September 3, 2025

Residence at Carter Lake – New Senior Living Facility – JGR Proj 25-3489

ADDENDUM NO. 1

Sheet C10

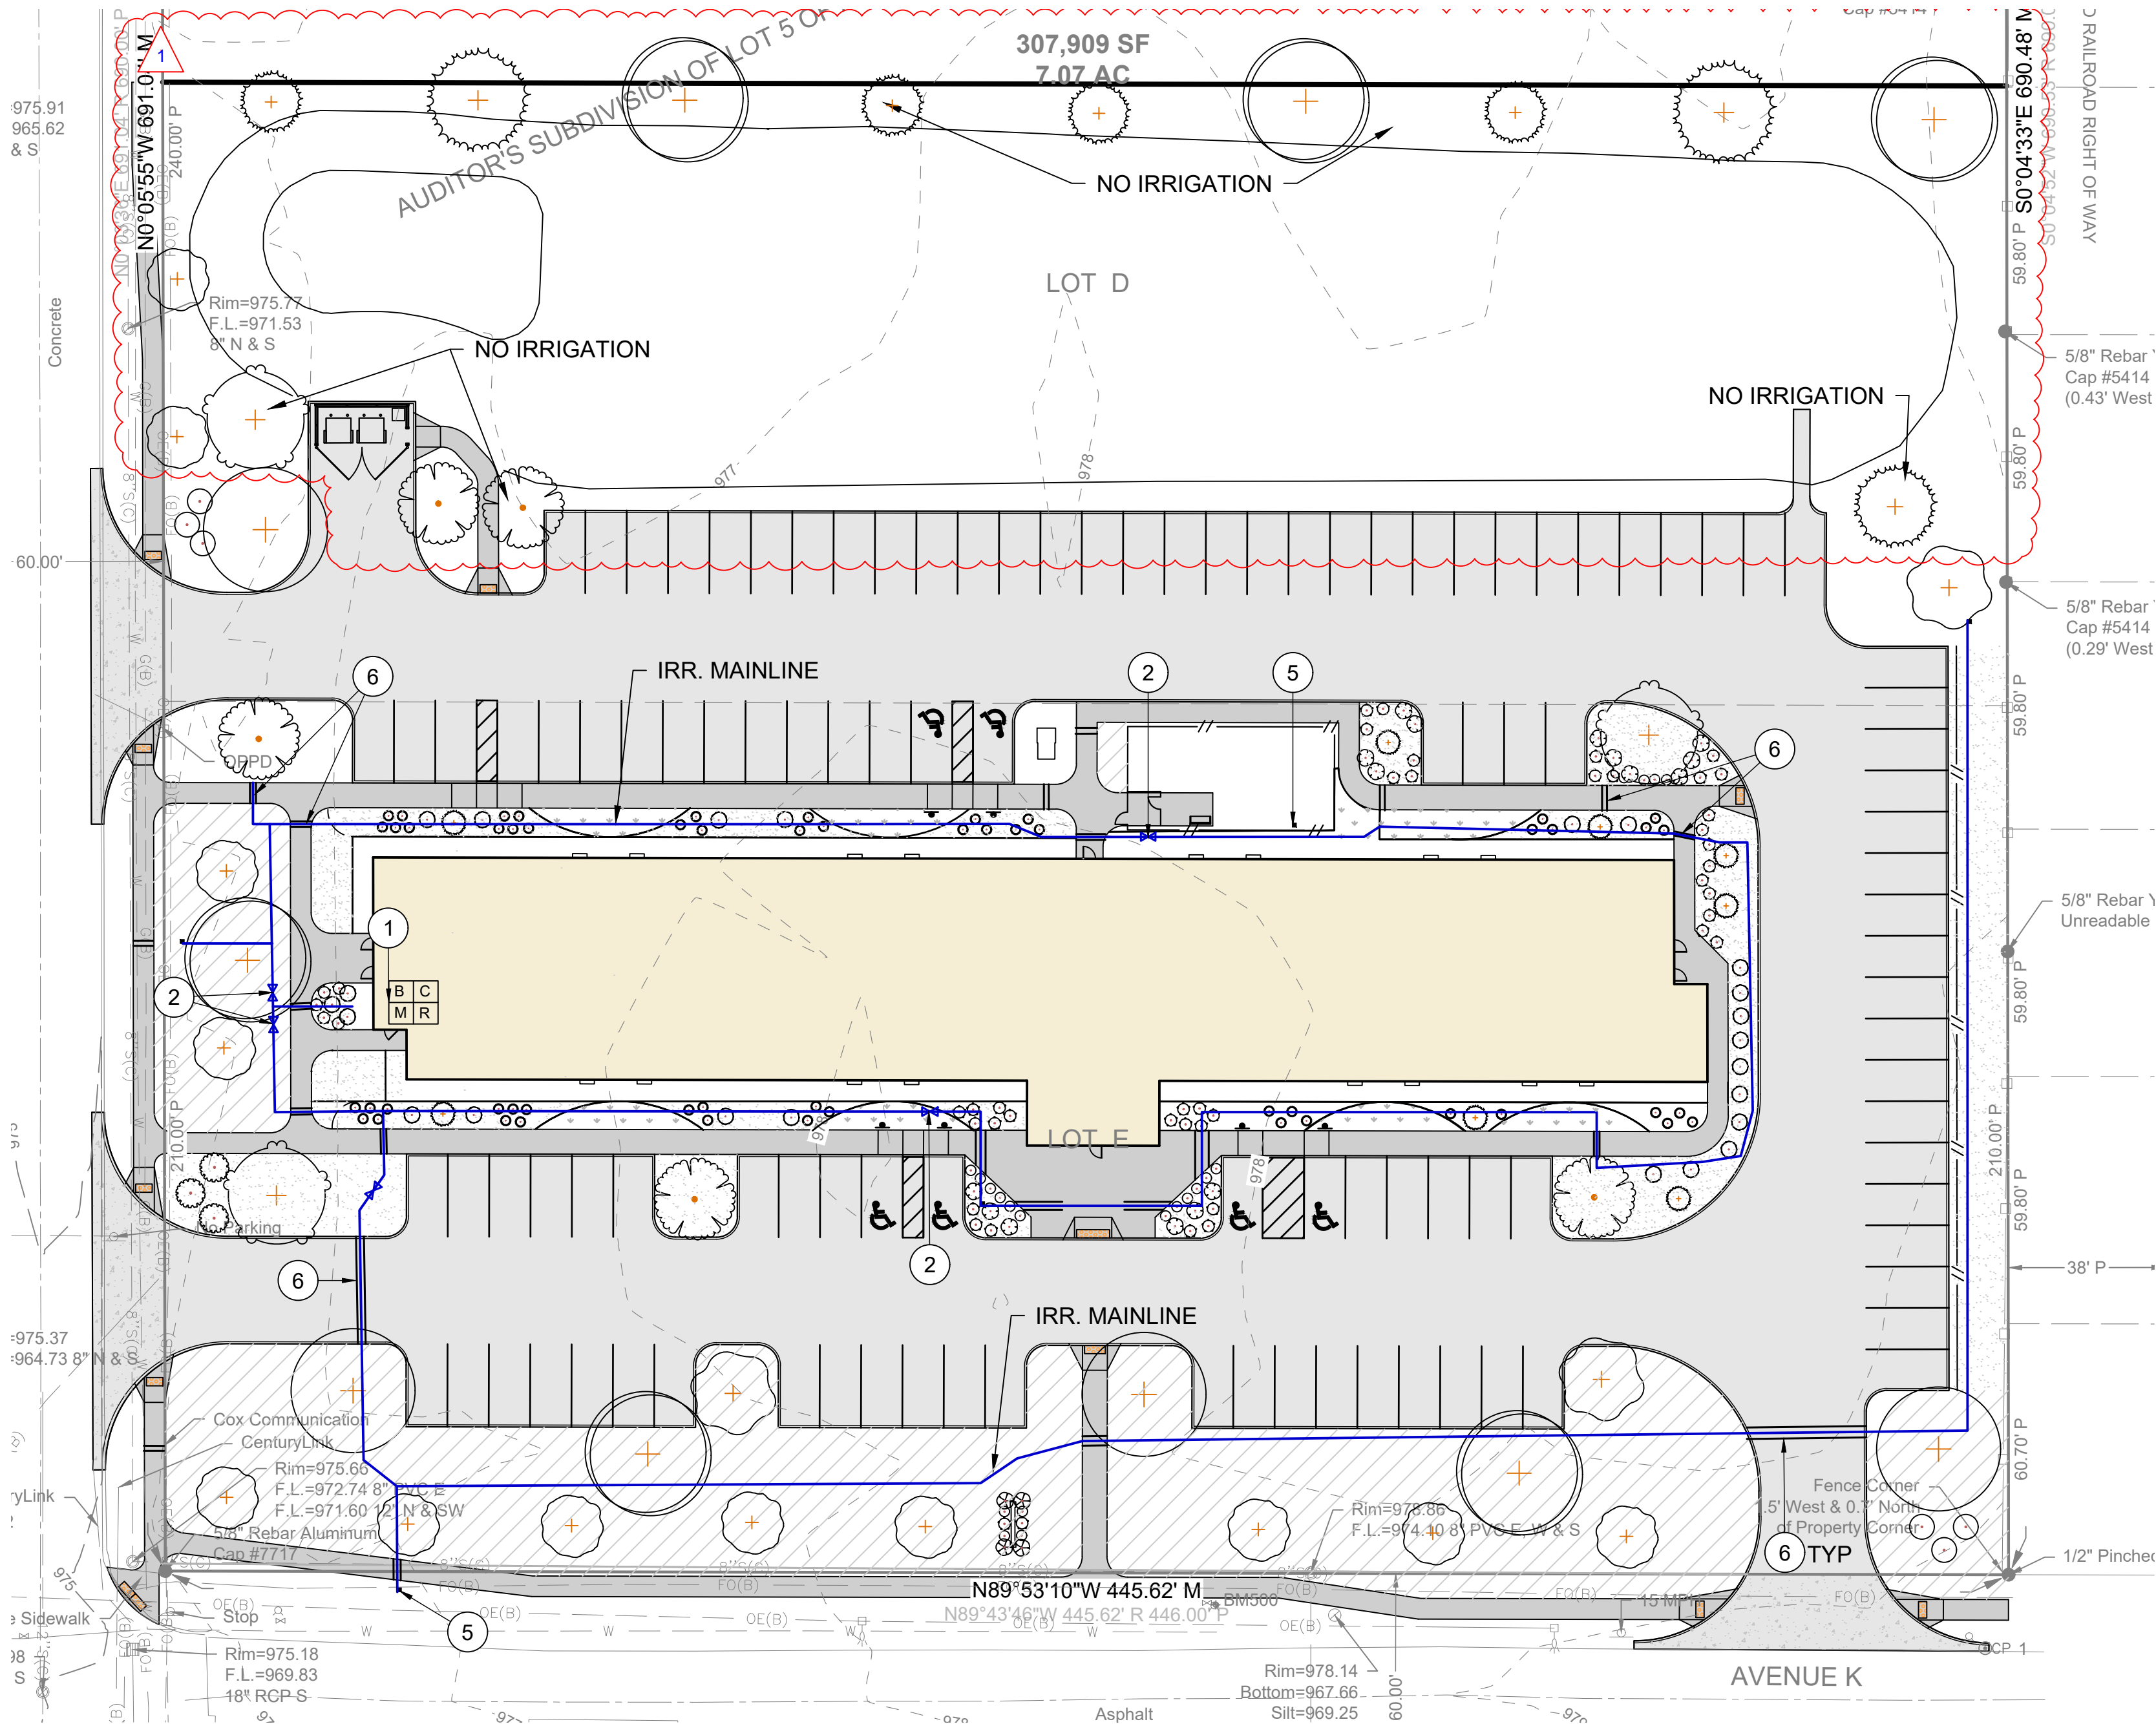
6. Sheet C9 - Updates to the planting plan to screen the pond and accommodate the grading changes.
7. Sheet C10 - Updates to show the larger pond, but it is not irrigated, so no changes to irrigation.

A **SECOND FLOOR PLAN**
3/32"=1'-0"

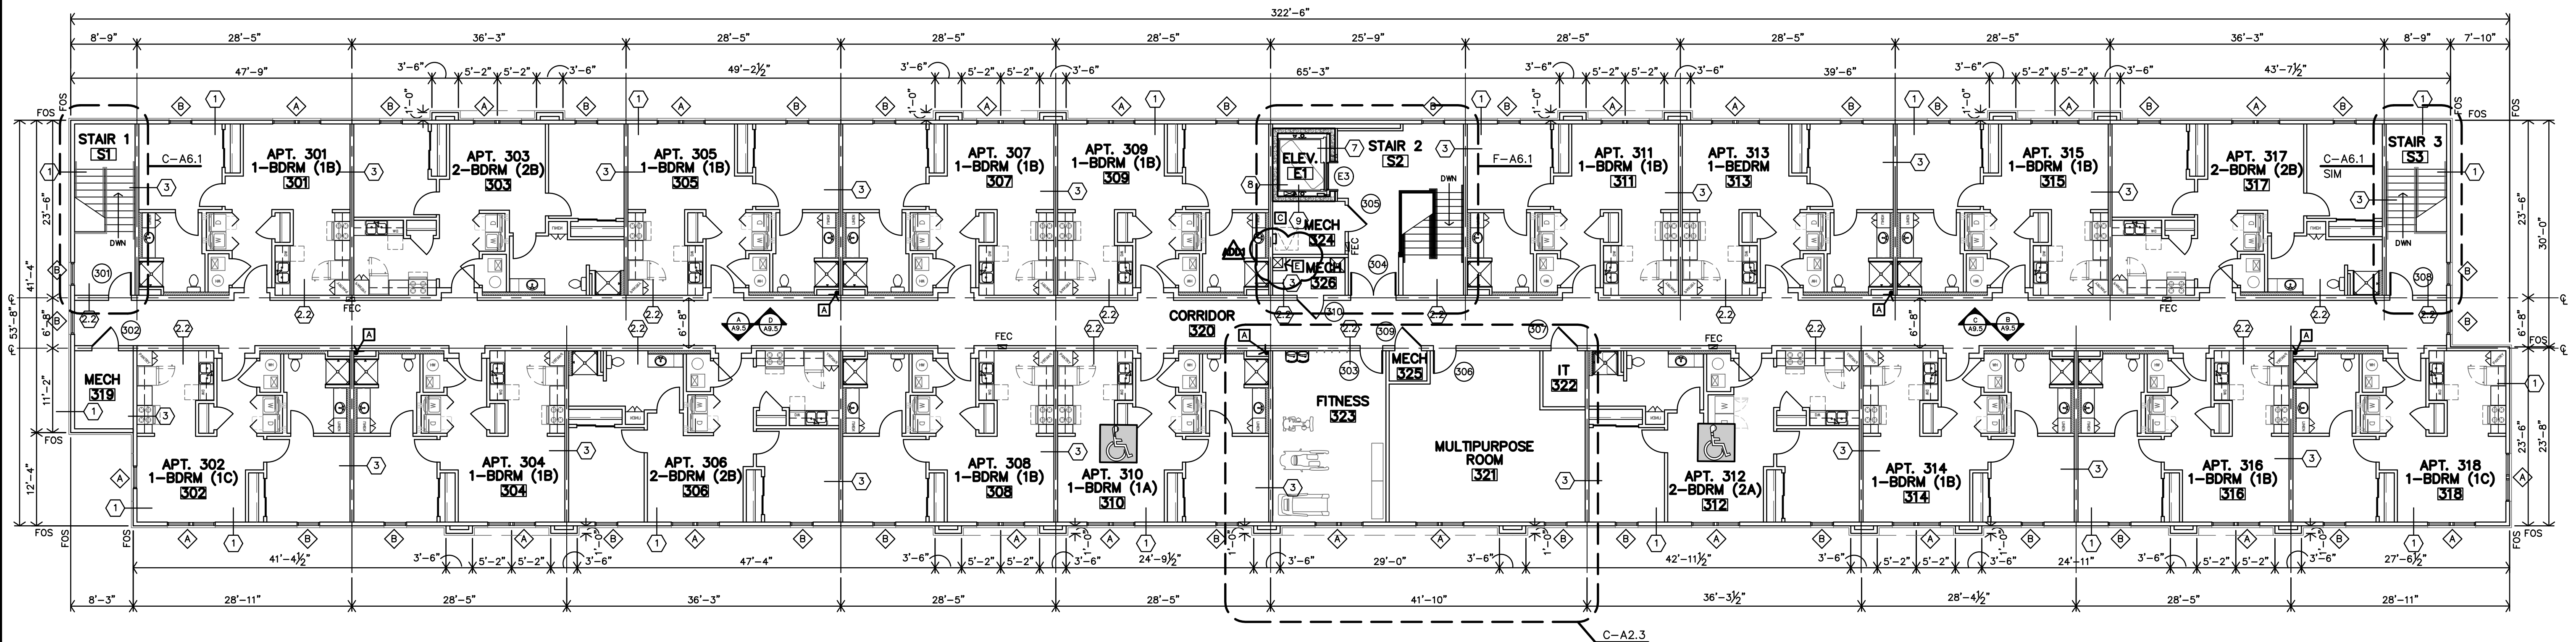
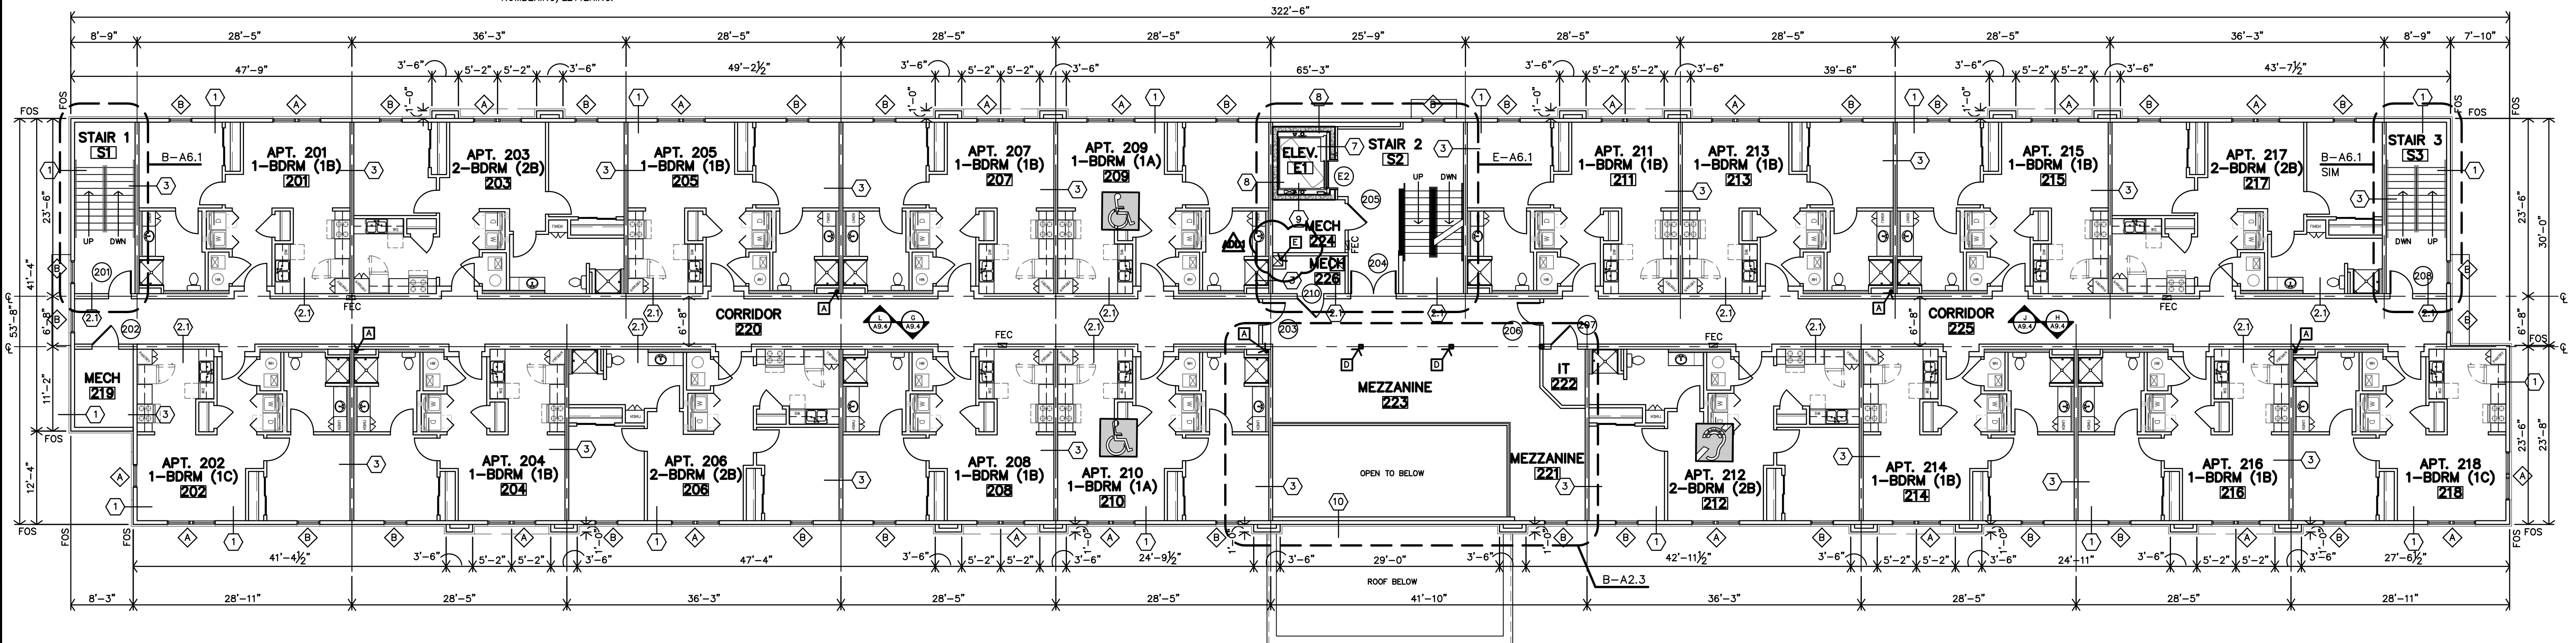
1. Sheet A2.2
 - a. Detail A – Rated chase & Note 'E' has been added to the corner of Mech Rm. 226
 - b. Detail B - Rated chase & Note 'E' has been added to the corner of Mech Rm. 326

- c. Legend – Note 'E' has been added.
2. Sheet A2.3 – Detail B - Elevation call-out on Mezzanine 223 has been changed to J-A9.2
3. Sheet A2.5 – Details D & E – 4" wood trim and gyp. board soffit has been added above the upper cabinets.
